**MOUNTAIN VIEW small LOT
R3 DESIGN STANDARDS**

THURSDAY SEPT 17, 2026 | STAFF DISCUSSION

HOUSING ELEMENT PROGRAM 1.3 & R3 STANDARDS

Figure 36.10.61.1: Parking Court

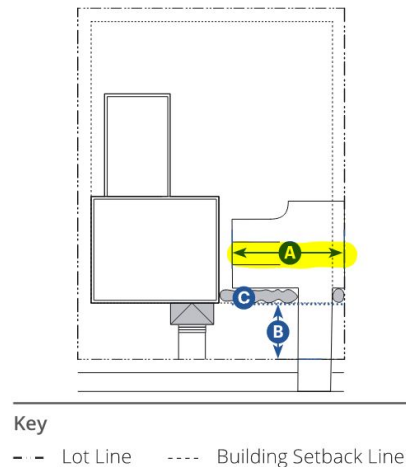
PARKING COURTS ONLY WORK ON WIDER LOTS (>80')

R3-B DESIGN GUIDELINES + ARTICLE X PARKING & LOADING

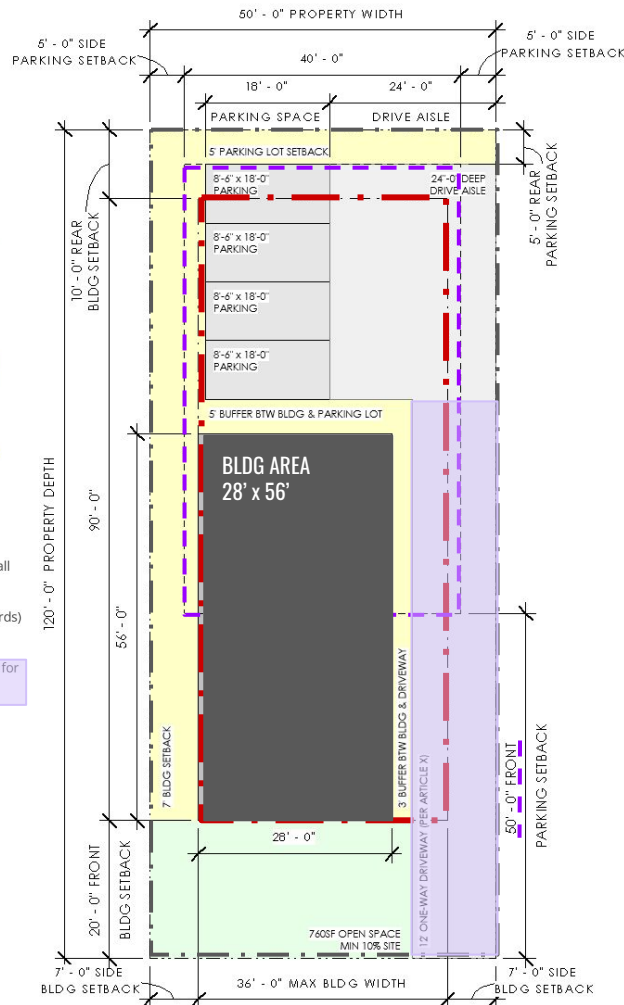
PARKING IN THE BACK ONLY WORKS WITH NARROW DRIVEWAYS

R3 small LOT PARKING RECOMMENDATIONS

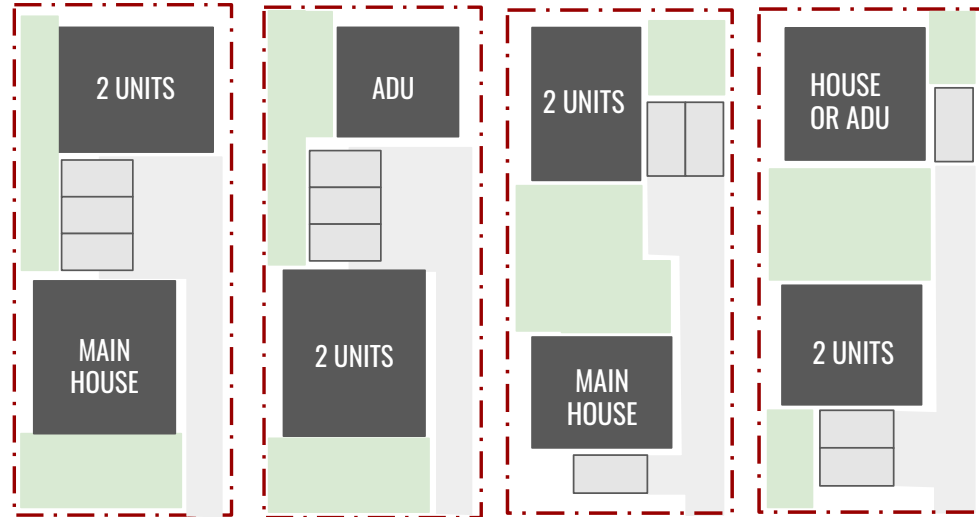
- Small lot parcels require parking space reductions
- 1 parking space per unit, regardless of unit size (studio, 1 br, 2 br, etc)
- No covered parking required
- Allow parking in front, side, rear setbacks
- Practical dimensions for R-3 parking
 - Each parking space is 8'-6" x 18'
 - Backup space is 24' deep
 - 3 spaces and backup 25'-6" x 42'
- Balance car parking with building square footage & resident open space

EXISTING TRIPLEX SITE LAYOUT IN DOWNTOWN MV

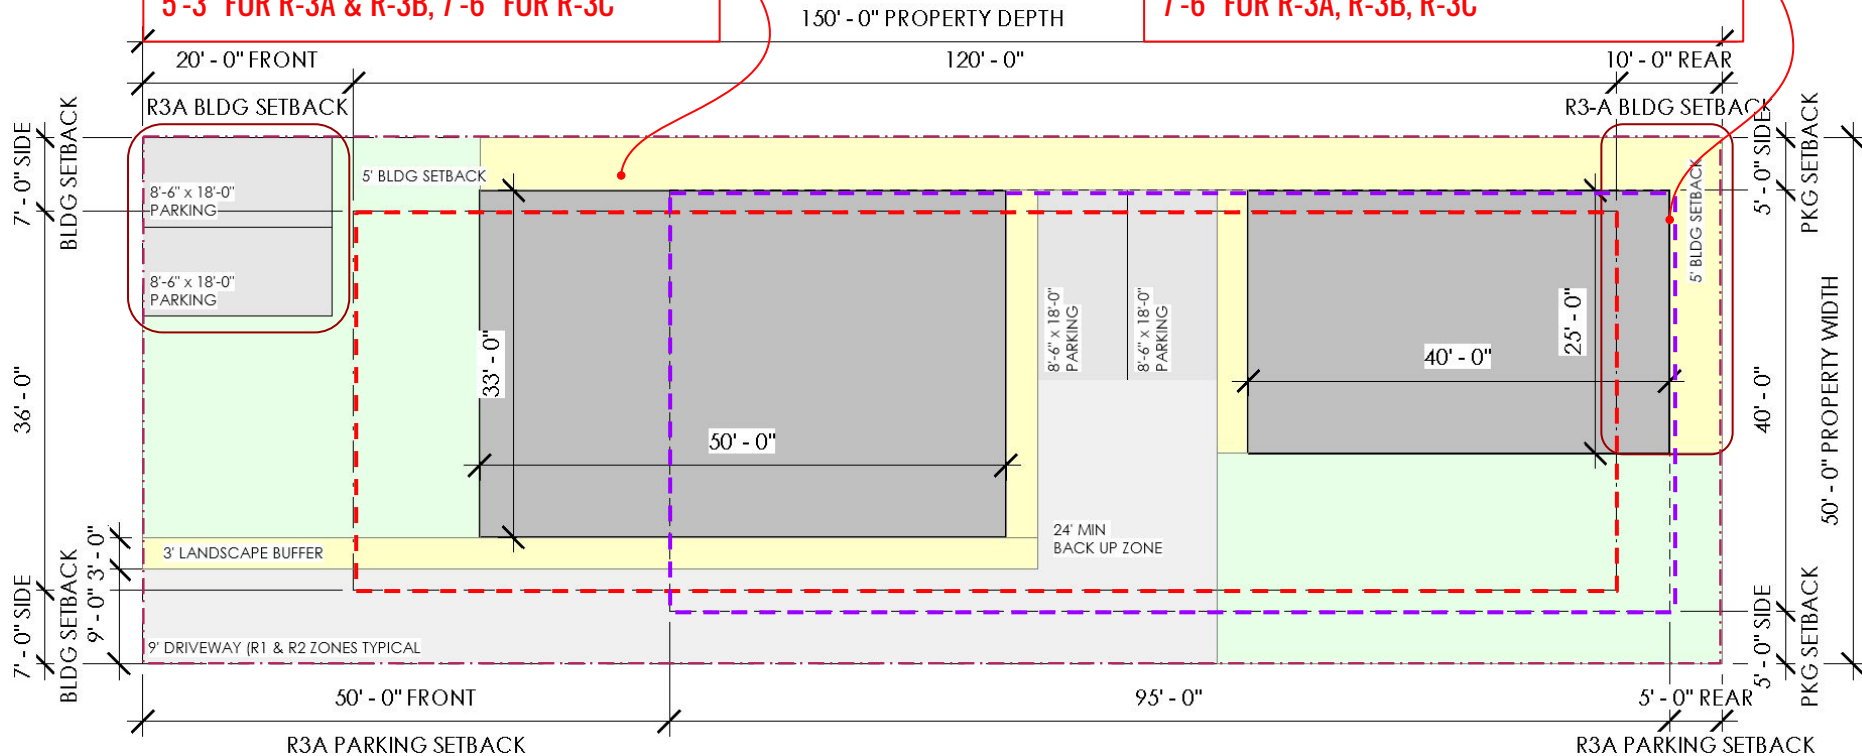
**25% SIDE BLDG SETBACK =
5'-3" FOR R-3A & R-3B
7'-6" FOR R-3C**

**NO PROVISIONS FOR
REDUCED DRIVEWAY
WIDTH**

**25% REAR BLDG SETBACK =
7'-6" FOR R-3A, R-3B R-3C**

RECOMMEND: 5'-0" SIDE SETBACK
25% SIDE SETBACK EXCEPTION NOT ENOUGH
5'-3" FOR R-3A & R-3B, 7'-6" FOR R-3C

RECOMMEND: 5'-0" REAR SETBACK
25% REAR SETBACK EXCEPTION NOT ENOUGH
7'-6" FOR R-3A, R-3B, R-3C

PRACTICAL R3 DESIGN STANDARDS - REAR PARKING

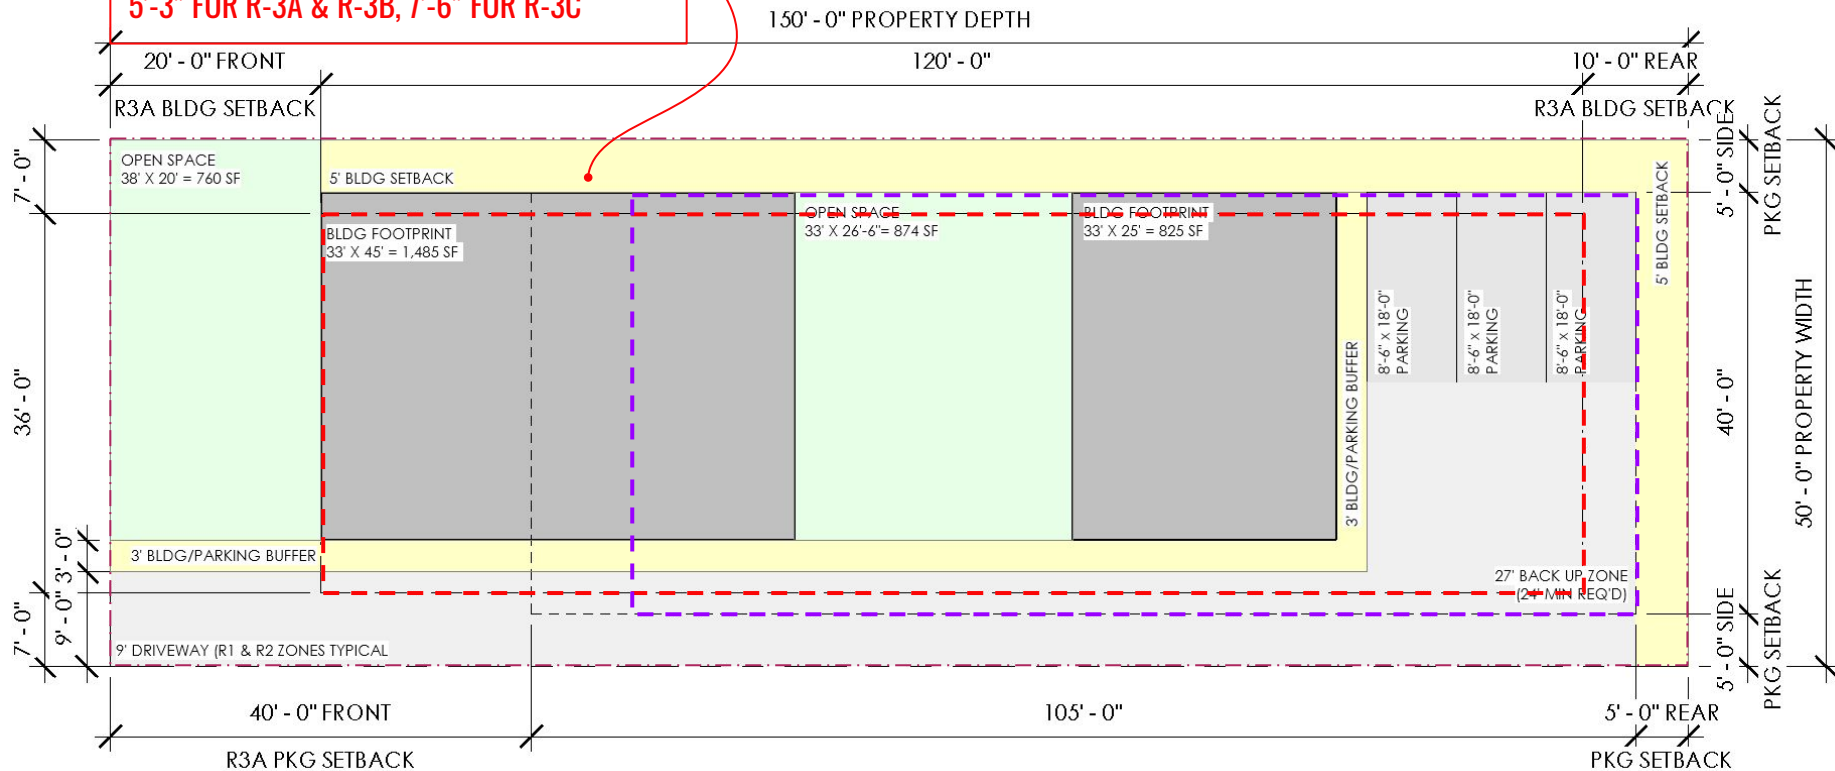
RECOMMEND: 5'-0" SIDE SETBACK
25% SIDE SETBACK EXCEPTION NOT ENOUGH
5'-3" FOR R-3A & R-3B, 7'-6" FOR R-3C
